Clause 163/163B Comment Resolution

Phil Sun

Credo Semiconductor

Figure 162-5—Differential to common-mode cable assembly return loss

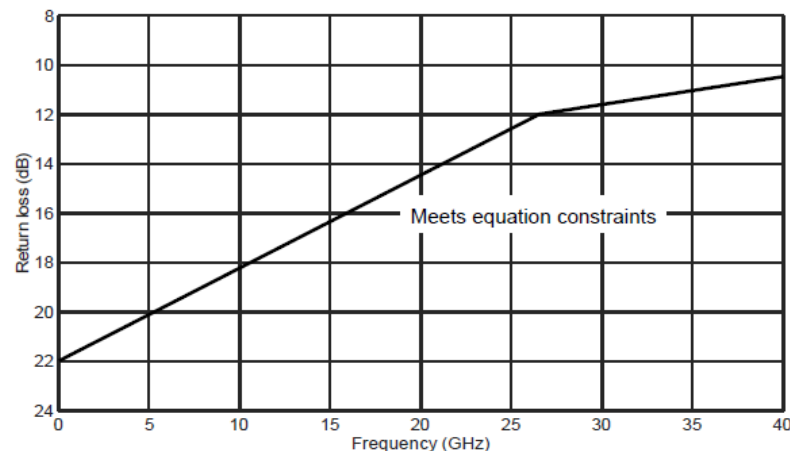
There is no specification for RLDC for the KR channel.

Without such specification, a channel can cause a strong common mode reflection signal that will be fed into the Tx - and since Tx RLCD/RLCC are not defined either, a differential or common mode signal can be reflected back without control.

The conversion loss specifications may need more work, but for the purpose of technical completeness, the channel RLDC from 162.11.4 can be used.

Add a new subclause for channel differential to common mode return loss, based on 162.11.4 with the same limits, with editorial license.

PROPOSED ACCEPT IN PRINCIPLE.
Implement the suggested remedy.
For task force discussion.
[Editor's note: CC 163, 120F]

Figure 163-5—Channel insertion loss limit

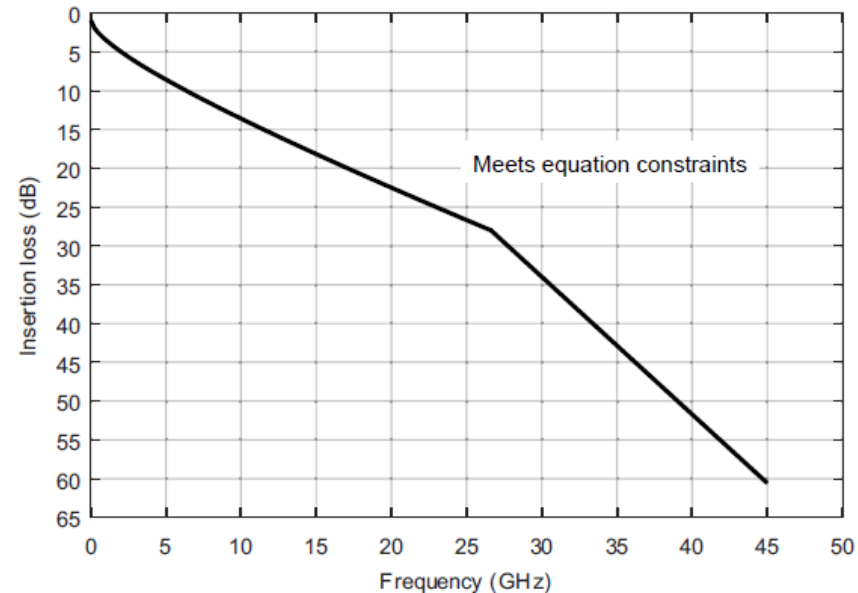
The limit at 40 GHz (not 45 as in the figure) excludes some acceptable channels.

Replace the straight part of the limit with one that curves down. (with an f^2 term). Correct the f_{max} in Figure 163-5.

There was an error in creating the figure that should be corrected.

Change figure 163-5 so curve ends at 40 GHz to match the equation.

The suggested remedy has not provided sufficient details to change the insertion loss curve. Also, the change is not required for technical completeness.
